MEMORANDUM

REVIEW TYPE: Preliminary Plan of Subdivision

PROJECT NAME: Avery Village

CASE #: 120070740

PRELIMINARY PLAN

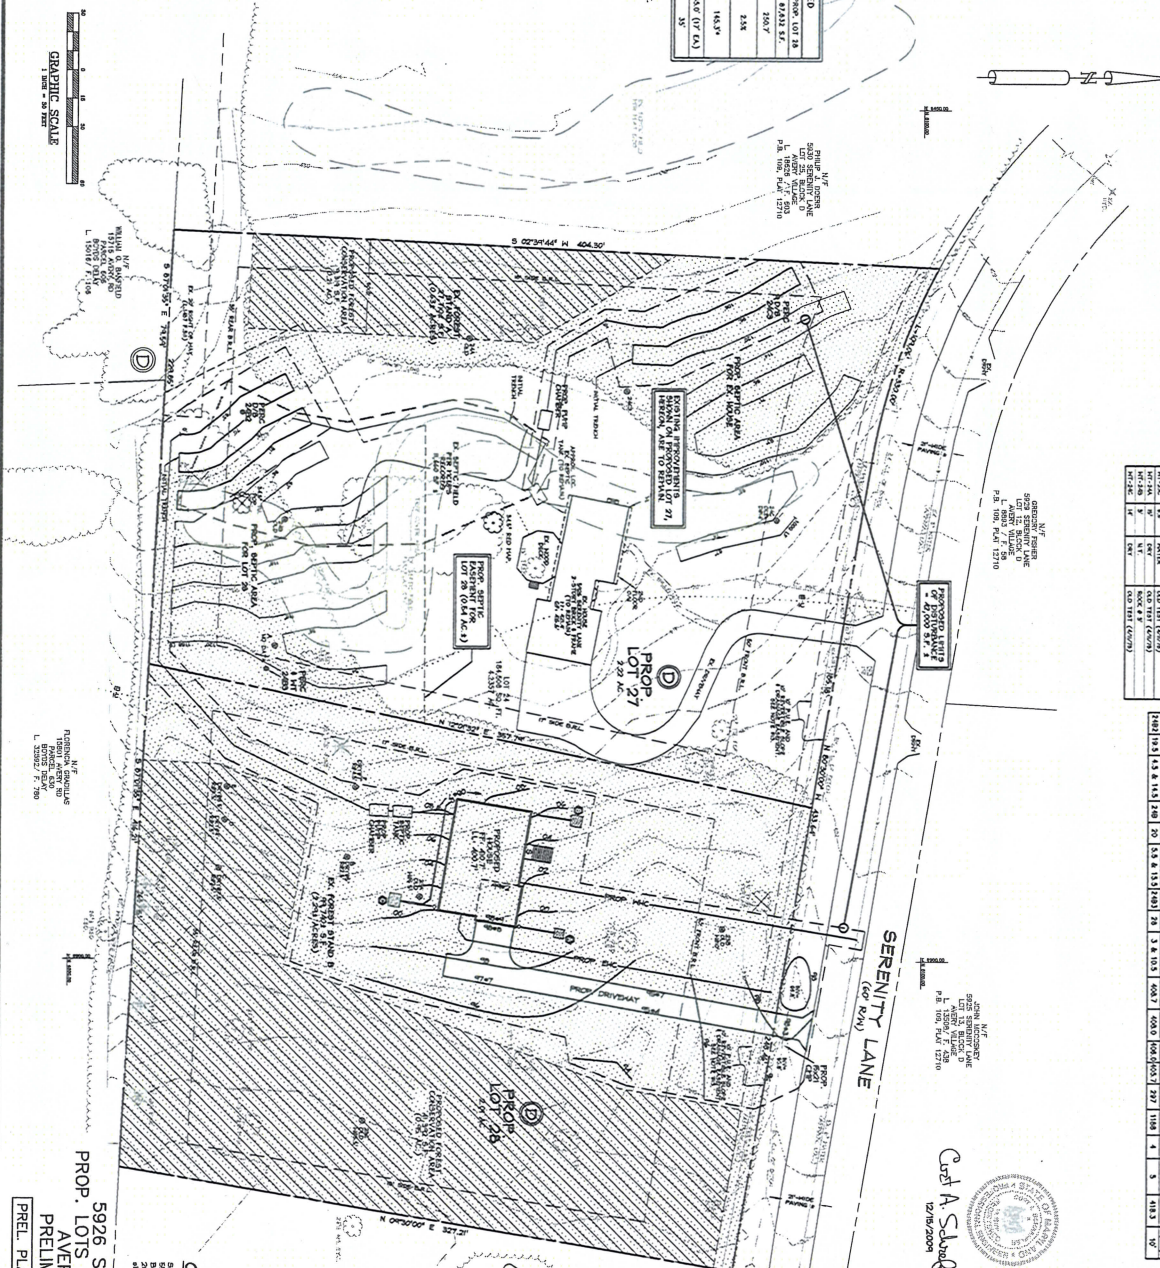
The applicant proposes to resubdivide the existing lot into two lots. The existing one-family detached dwelling will be retained on proposed Lot 27 and one new one-family detached dwelling will be constructed on proposed Lot 28. Proposed Lot 27 will be 2.22 acres in size and proposed Lot 28 will be 2.01 acres in size. Access to the lots will be via separate driveways from Serenity Lane. The residences will be served by public water and private septic systems.

(Attachment B – proposed plan)

The subject property contains 2.92-acres of existing forest, and 1.76-acres of forest clearing is shown on the preliminary forest conservation plan. The property is located in the RE-2 zone, and has a land use category of Medium Density Residential (MDR) for forest conservation purposes. The MDR land use category has a 20 percent afforestation threshold and 25 percent conservation threshold. The breakeven point, or the amount of forest that can be cleared without mitigation, is 1.49-acres. The plan as currently shown would clear 0.27-acres

more forest than the breakeven point and generate a 0.34-acre planting requirement which is proposed to be completed off-site.

The lots were reviewed for compliance with the dimensional requirements for the RE-2 zone as specified in the Zoning Ordinance. The lots as proposed will meet all the dimensional requirements for area, frontage, width, and setbacks in that zone. A summary of this review is included in attached Table 1. The application has been reviewed by other applicable county agencies, all of whom have recommended approval of the plan.

NEIGHBORHOOD MAP

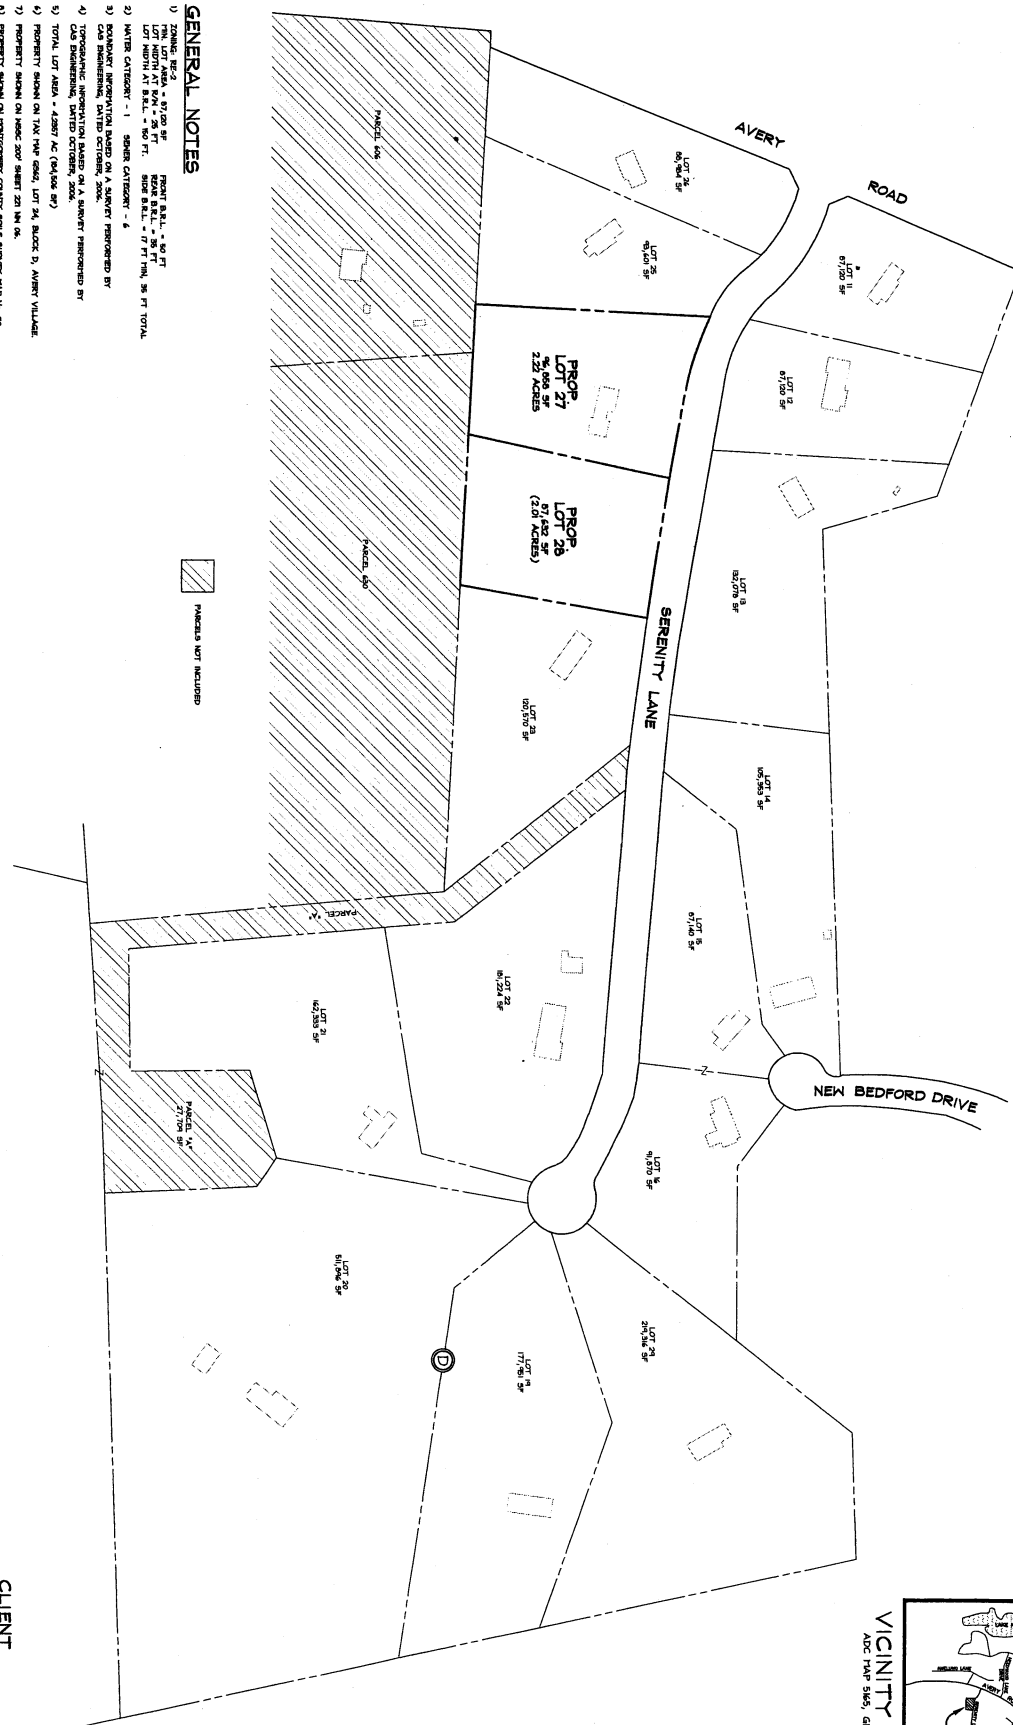
In administering Section 50-29(b)(2) of the Subdivision Regulations, the Planning Board must determine the appropriate “neighborhood” for evaluating the application. In this instance, the Neighborhood selected by the applicant, and agreed to by staff, consists of 14 lots (Attachment C). The neighborhood includes lots on Serenity Lane and New Bedford Drive in the RE-2 zone. All the lots share access on these two streets. The designated neighborhood provides an adequate sample of the lot and development pattern of the area. A tabular summary of the area based on the resubdivision criteria is included in Attachment D.

In performing the analysis, the above-noted resubdivision criteria were applied to the delineated neighborhood. The proposed lots are of the same character with respect to the resubdivision criteria as other lots within the defined neighborhood. Therefore, the proposed resubdivision complies with the criteria of Section 50-29(b)(2). As set forth below, the attached tabular summary and graphical documentation support this conclusion:

In a neighborhood of 14 lots, lot frontages range from 35 feet to 778 feet. Three of the lots have frontages of less than 60 feet, six lots have frontages between 60 and 300 feet, and the remaining five lots have frontages of more than 300 feet. Proposed Lot 27 has a frontage of 294 feet, and proposed Lot 28 has a frontage of 248 feet. **The proposed lots will be of the same character as existing lots in the neighborhood with respect to lot frontage.**

Seven of the 14 existing lots in the neighborhood are radial in alignment, Three are angled, two are perpendicular, and the remaining two are corner lots. One proposed lot is angled and one is perpendicular in alignment. **The proposed lots are of the same character as existing lots with respect to the alignment criterion.**

The lots in the delineated neighborhood range from 87,120 square feet to 511,896 square feet. Six of the lots are smaller than 100,000 square feet, seven are between 100,000 and 220,000 square feet, and one is larger than 500,000 square feet. Proposed Lot 27 is 96,858 square feet in size and Proposed Lot 28 is 87,632 square feet in size. **The proposed lot sizes are in character with the size of existing lots in the neighborhood.**

Nine of the existing lots in the neighborhood are irregularly shaped, four are trapezoidal, and the remaining one is a pipestem lot. The two proposed lots are trapezoidal. **The shapes of the proposed lots will be in character with shapes of the existing lots.**

The lots in the delineated neighborhood range from 133 feet to 657 feet in width. Seven of the lots have widths of less than 200 feet, four lots have widths between 200 and 400 feet, and the remaining three lots have widths of more than 400 feet. Proposed Lot 27 has a width of 283 feet and proposed Lot 28 has a width of 251 feet. **The proposed lots will be in character with existing lots in the neighborhood with respect to width.**

feet, four are between 100,000 and 200,000 square feet, and one is over 400,000 square feet. Proposed Lot 27 has a buildable area of 65,275 square feet and proposed Lot 28 has a buildable area of 58,082 square feet. Although the buildable area of proposed Lot 28 is well within the range of neighborhood lots, the usable buildable area will be constrained by an on-lot forest conservation easement. After subtracting the easement area, the buildable area would be reduced to approximately 31,000 square feet. While this is less than the buildable area of any of the neighborhood lots, the lot is still left with more than adequate space for placement of a residence and accessory structures. Further, it is not staff's practice to account for easements when calculating buildable area for resubdivision purposes. **The proposed lots will be of the same character as other lots in the neighborhood with respect to buildable area.**
